NAMANWOOD SUBDIVISION

APPLICATION NUMBER 11 DATE March 5, 2015

REQUEST Subdivision

DETAIL SITE PLAN

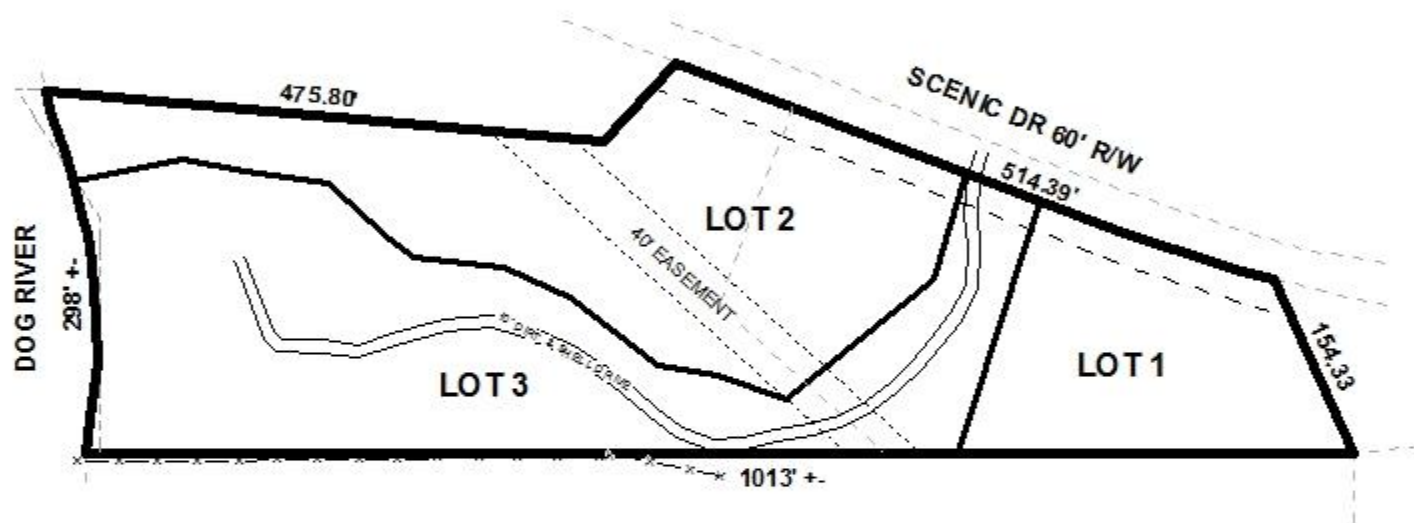
- A. Add a note to the SUBDIVISION PLAT stating that a Land Disturbance permit will be required for any land disturbing activity in accordance with Mobile City Code, Chapter 17, Storm Water Management and Flood Control); the City of Mobile, Alabama Flood Plain Management Plan (1984); and, the Rules For Erosion and Sedimentation Control and Storm Water Runoff Control.

- B. Add a note to the Plat stating that the approval of all applicable federal, state, and local agencies (including all storm water runoff, wetland and floodplain requirements) will be required prior to the issuance of a Land Disturbance permit.

- C. Show and label all flood zones.
- D. Show and label the MFFE (Minimum Finished Floor Elevation) on each LOT that contains an AE, V, or X (shaded) flood zone designation.

- E. Provide and label the monument set or found at each subdivision corner.
- F. Provide the Surveyor's, Owner's (notarized), Planning Commission, and Traffic Engineering signatures.

- G. Add a note that sidewalk is required to be constructed, and/or repaired, along the frontage of each lot, or parcel, at time of development, unless a sidewalk waiver is approved.

Traffic Engineering Comments: Each lot is limited to one curb cut, with size, location and design to be approved by Traffic Engineering and conform to AASHTO standards.

Each lot meets the minimum area and width requirements of the Subdivision Regulations. As proposed, Lots 2 and 3 would have an irregularly-shaped common interior property line resulting in those two lots being irregularly shaped. Section V.D.1. of the Subdivision Regulations does not generally allow for such shapes unless certain conditions exist in the area which would justify such shapes. One such allowance is the existence of natural barriers which may cause an undue hardship on the land owner. A review of topographic and hydrographic data indicates that a large finger of NWI wetlands extends from Dog River on the West side of the site into the approximate center of the site. The meandering proposed interior line between Lots 2 and 3 closely follows the South border of the wetlands area to a point where the line approximately parallels an existing driveway on proposed Lot 3. The applicant's design professional has indicated that the purpose of the Subdivision is to separate the developed portion of the site from the wetlands and flood zone area. Therefore, a waiver of Section V.D.1. would be in order. Lots 2 and 3 would also require a waiver of Section V.D.3. for the width-to-depth ratio of those lots, but existing lots along Dog River are typically much deeper than they are wide; therefore, a waiver of Section V.D.3. would also be in order. Proposed Lot 1 would not require any waivers.

As on the preliminary plat, the Final Plat should also label each lot with its size in both square feet and acres, or a table should be furnished on the Final Plat providing the same information. And as on the preliminary plat, the 25' minimum building setback line should also be illustrated on the Final Plat.

With waivers of Sections V.D.1. and V.D.3., the plat meets the minimum requirements of the Subdivision Regulations and is recommended for tentative approval, subject to the following conditions:

- 1) placement of a note on the Final Plat stating that each lot is limited to one curb cut to Scenic Drive, with the size, design and location to be approved by Traffic Engineering and conform to AASHTO standards;

- 2) retention of the labeling of each lot with its size in acres and square feet, or the furnishing of a table on the Final Plat providing the same information;

- 3) retention of the 25' minimum building setback line on each lot;
- 4) subject to the Engineering comments: *(The following comments should be addressed prior to submitting the FINAL PLAT for acceptance and signature by the City Engineer: A. Add a note to the SUBDIVISION PLAT stating that a Land Disturbance permit will be required for any land disturbing activity in accordance with Mobile City Code, Chapter 17, Storm Water Management and Flood Control); the City of Mobile, Alabama Flood Plain Management Plan (1984); and, the Rules For Erosion and Sedimentation Control and Storm Water Runoff Control. B. Add a note to the Plat stating that the approval of all applicable federal, state, and local agencies (including all storm water runoff, wetland and floodplain requirements) will be required prior to the issuance of a Land Disturbance permit. C. Show and label all flood zones. D. Show and label the*
